September 16, 2009
U7-C-STP-NRC-090134

South Texas Project
Units 3 and 4
Docket Nos. 52-012 and 52-013
Responses to Requests for Additional Information

Attached are responses to NRC staff questions in Request for Additional Information (RAI) letter number 185, related to COLA Part 2, Tier 2, Sections 2.4S.5, "Probable Maximum Surge and Seiche Flooding," 2.4S.6, "Probable Maximum Tsunami Hazards," and 2.4S.13, "Accidental Releases of Radioactive Liquid Effluents in Ground and Surface Waters."

Figure 2.4S.5-XX. USGS Quadrangle showing Little Robbins Slough and Colorado River relative to the STP 3 & 4 Main Cooling Reservoir (MCR).

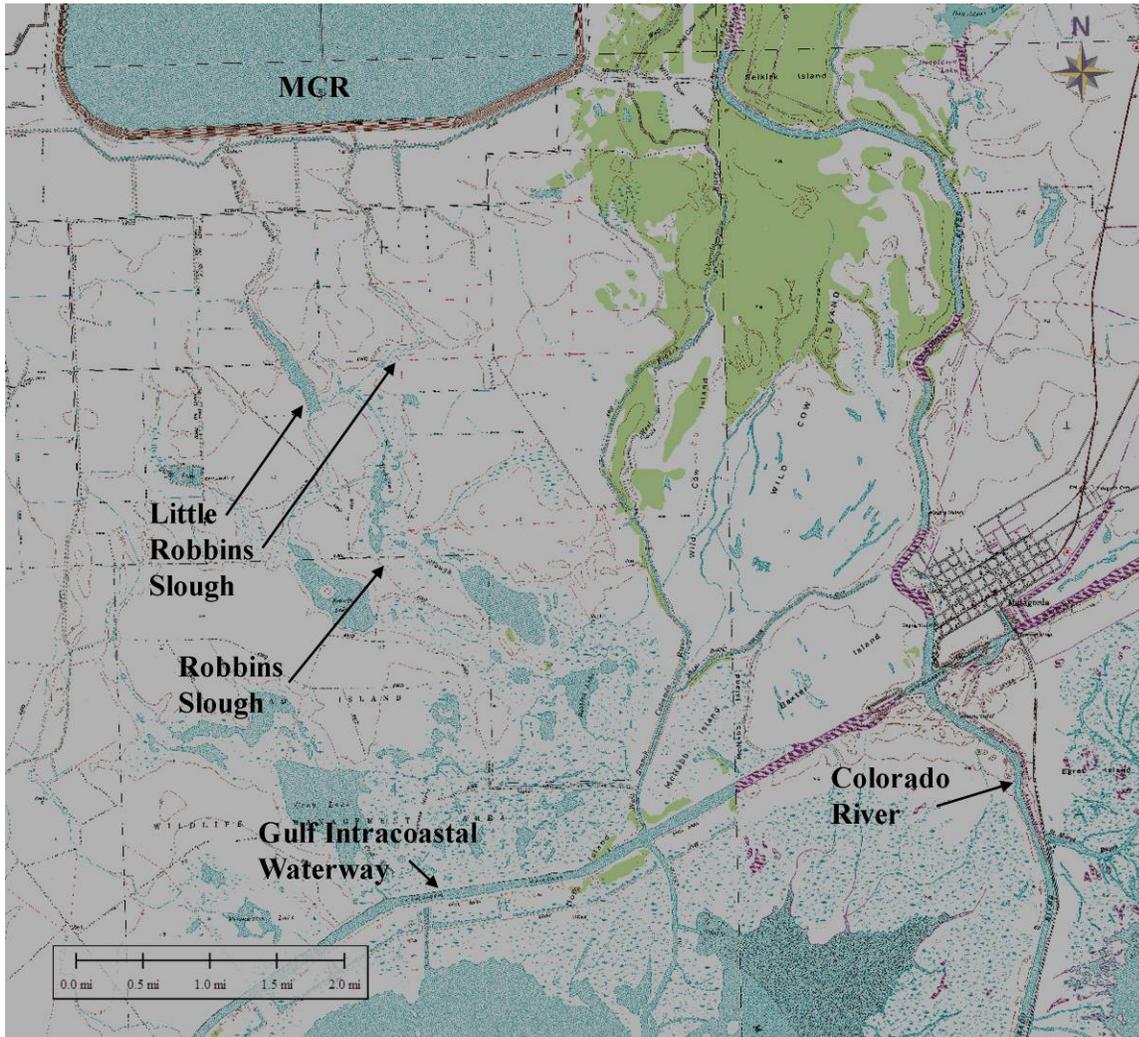
The applicant responded to RAI 02.04.05-3 in a letter dated August 27, 2008. The staff determined that the justification for not performing a PMH backwater calculation for the Little Robbins Slough should be included in the FSAR. Provide proposed text changes for FSAR Section 2.4.5 that address this issue.

The first paragraph of Subsection 2.4S.5.2.3.2 of STP COLA FSAR, Revision 3, which will be submitted in September, 2009, will be revised to include the justification provided in the response to RAI 02.04.05-3 for not performing a PMH backwater calculation for the Little Robbins Slough:

“A modified version of the Halff HEC-RAS hydraulic model (i.e., Reference 2.4S.5-10) was used to estimate the water surface elevation at STP 3 & 4 based on a backwater calculation on the Colorado River using the storm surge water surface elevation near the open coast as the downstream boundary condition. The Halff HEC-RAS model was developed for Halff’s flood damage evaluation study and is discussed extensively in Subsection 2.4S.3. To be on the conservative side, however, the floodplain-extension used in HEC-RAS model of Subsection 2.4S.3 was not adopted in estimating the storm surge at STP 3 & 4. Little Robbins Slough near the STP site, shown in Figure 2.4S.5-XX, is a shallow multi-channel slough that joins Robbins Slough, a brackish marsh, which eventually drains to the Gulf Intracoastal Waterway. With the PMSS, it would be completely submerged and drowned out, thereby resulting in negligible water surface slopes for the backwater calculation. Therefore, the Colorado River is used for the PMSS backwater calculation in order to generate a bounding PMSS water level at STP 3 & 4.”

Figure 1. Submarine Mass Failure (SMF) regions in the Gulf of Mexico (Reference 3). Gulf of Mexico depth contours shown in meters below present-day sea level (Source: Reference 4).

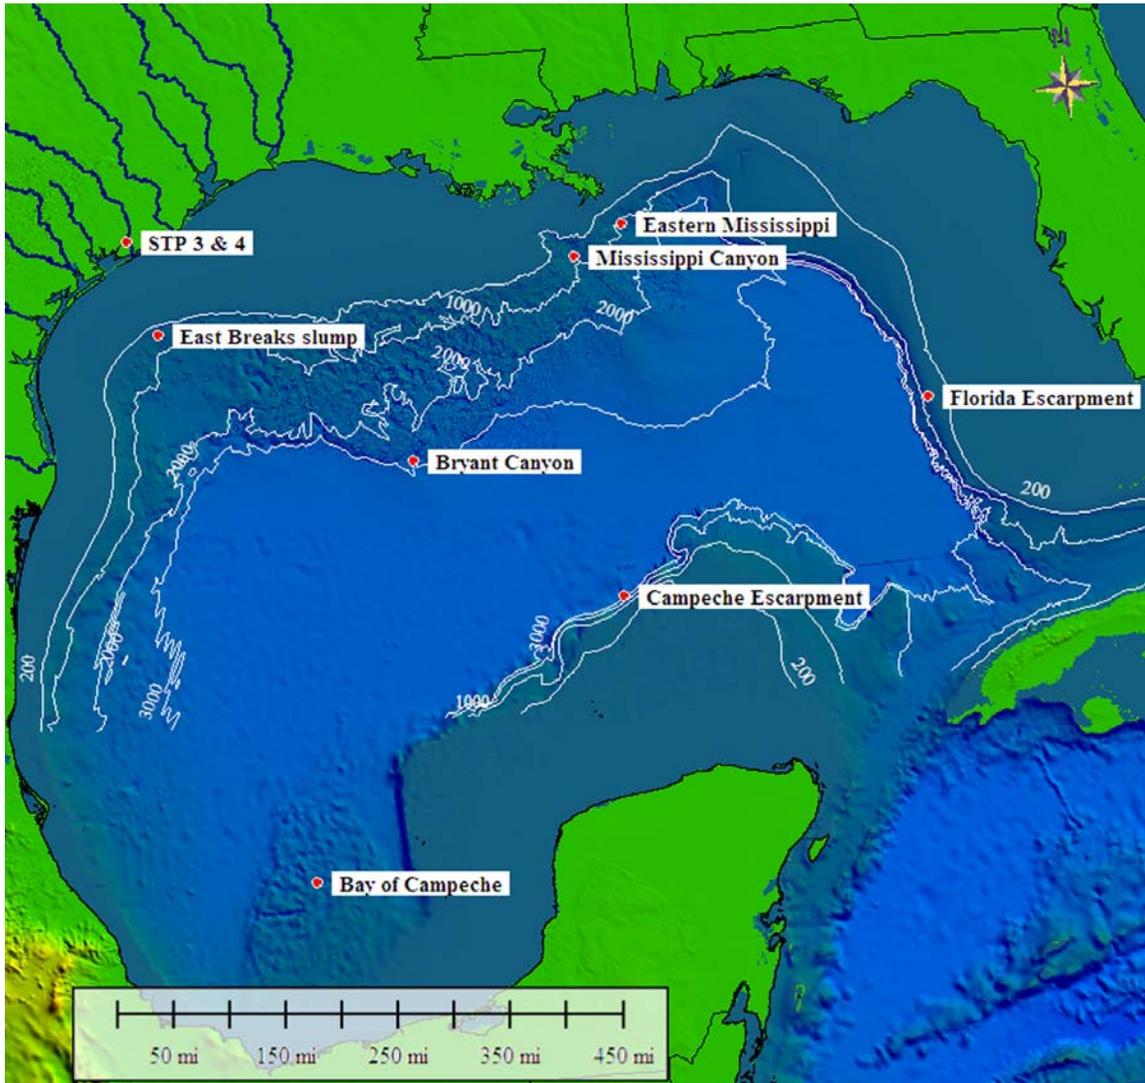
In the review by the staff of the response to RAI 02.04.06-1 (U7-C-STP-NRC-080067, December 4, 2008), the staff has generated the following additional questions: (1) It appears that the applicant's maximum tsunami water levels are not runup levels (including overland flow) but shoreline water surface elevations; (2) The applicant does not provide sufficient justification to dismiss the possibility that the Campeche Escarpment is a potential source for the PMT water levels; and (3) The applicant discusses the finding that no evidence of tsunami deposits was found near the site and that potential tsunami deposits from the East Breaks source would have been emplaced during sea-level low stand. However, they do not mention older tsunami deposits that occur during sea-level high stands, such as the Falls County tsunami deposit (Bourgeois and others, 1988). The applicant should clarify these issues and provide proposed text changes for FSAR Sections 2.4S.6.

With respect to Item (2), the Campeche Escarpment is located approximately 873 km (542 mi) from the STP 3 & 4 site. The Campeche Escarpment is much further away from the STP 3 & 4 site than the East Breaks slump, which is located about 142 km (88 mi) from the STP 3 & 4 site. Locations of the Campeche Escarpment and the East Breaks slump are shown in Figure 1 of this response. It is explained in the response to RAI 02.04.06-1 that tsunamis generated from submarine mass failures (SMFs) from remote areas of the Gulf of Mexico, such as the Campeche Escarpment, are not expected to exceed the four initial conditions simulated for the East Breaks slump. Maximum wave heights and minimum wave heights for the four simulated initial conditions are listed in Table 1.

Source parameters for the Campeche Escarpment postulated in Reference 3 do not exceed the source parameters that were simulated for the East Breaks slump in RAI 02.04.06-1. In addition, as tsunamis generated from landslides tend to be steep (i.e., high initial wave height relative to wavelength) and are prone to breaking, a tsunami event from a SMF in the Campeche Escarpment is not expected to propagate across the Gulf of Mexico and sustain wave heights that exceed the four simulated initial conditions for the East Breaks slump. As shown with the model simulations for the East Breaks slump, significant diffusion and energy dissipation of large initial waves occurs due to the continental shelf that extends offshore of the South Texas coast. Therefore, runup along the South Texas coast from a Campeche Escarpment event is likely to be negligible.

Figure 2.4S.13-1 Decay Chains Considered in Accidental Effluent Release

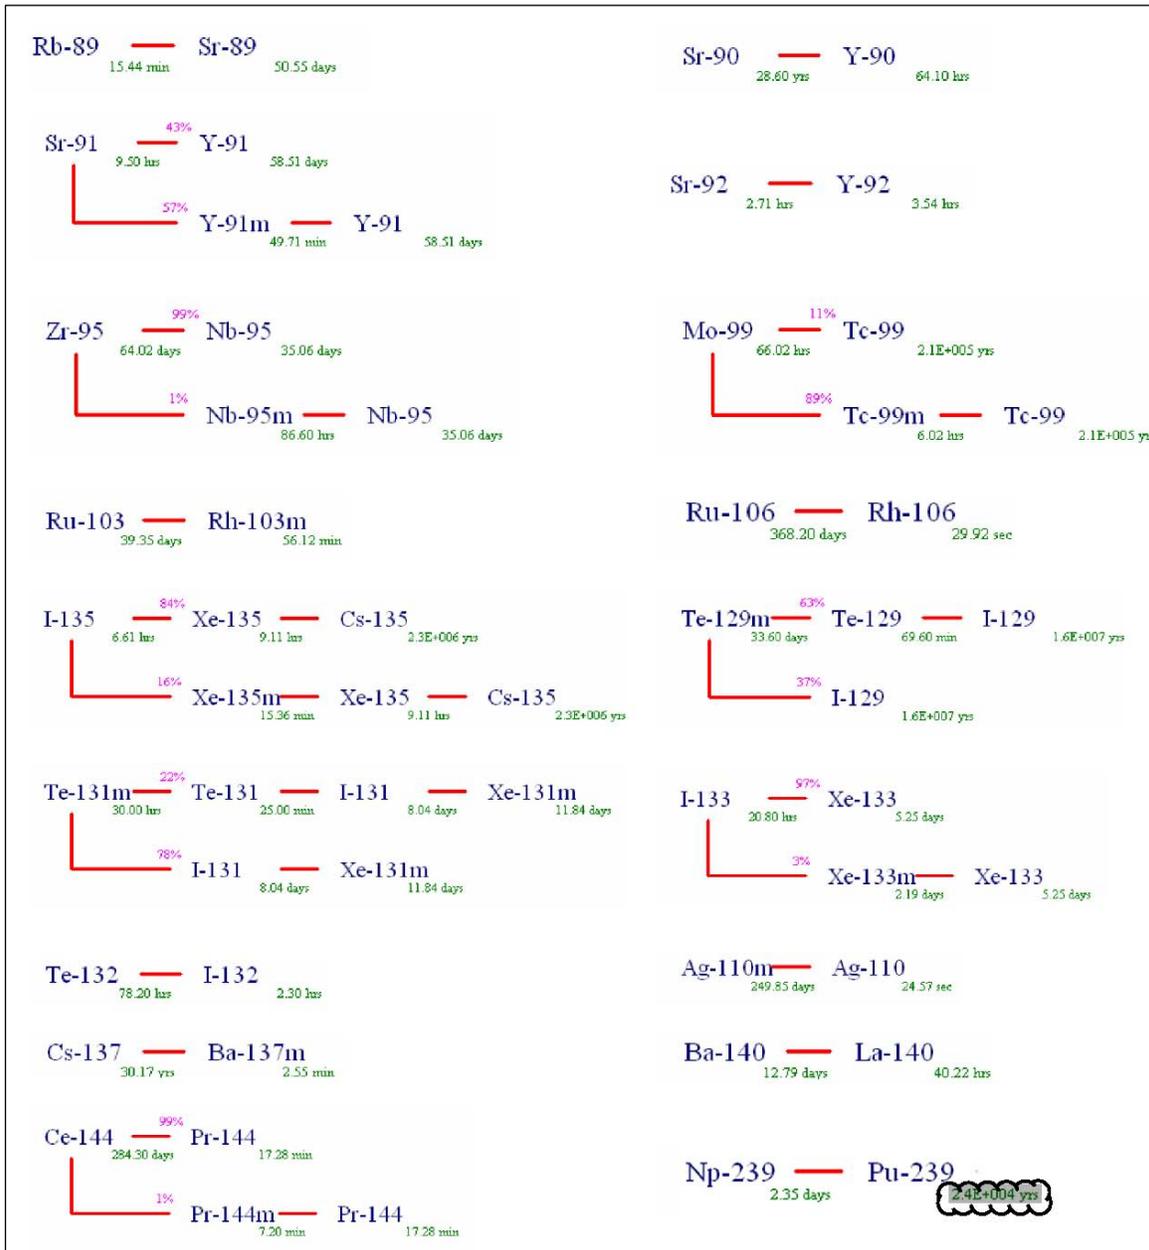
(B) (7) footnote column "10% probability K_d" entries in Table 2.4S13.4 to identify their origin (the values do not appear in NUREG/CR 6697), (8) further justify the use of non-site-specific K_d data and the 10th percentile value in particular as opposed to a lower value, and (9) correct the truncated half-life of Pu239 in Figure 2.4S.13-1.

(B)(9) Figure 2.4S.13-1 of the STP Units 3 and 4 FSAR will be revised to show the half-life of Pu-239 as 2.4 E+004 years, as indicated in the markups provided at the end of this RAI response.

As discussed in Item (B)(9) above, FSAR Figure 2.4S.13-1 will be revised as indicated by the “cloud” marking in the figure markup provided on the following page.
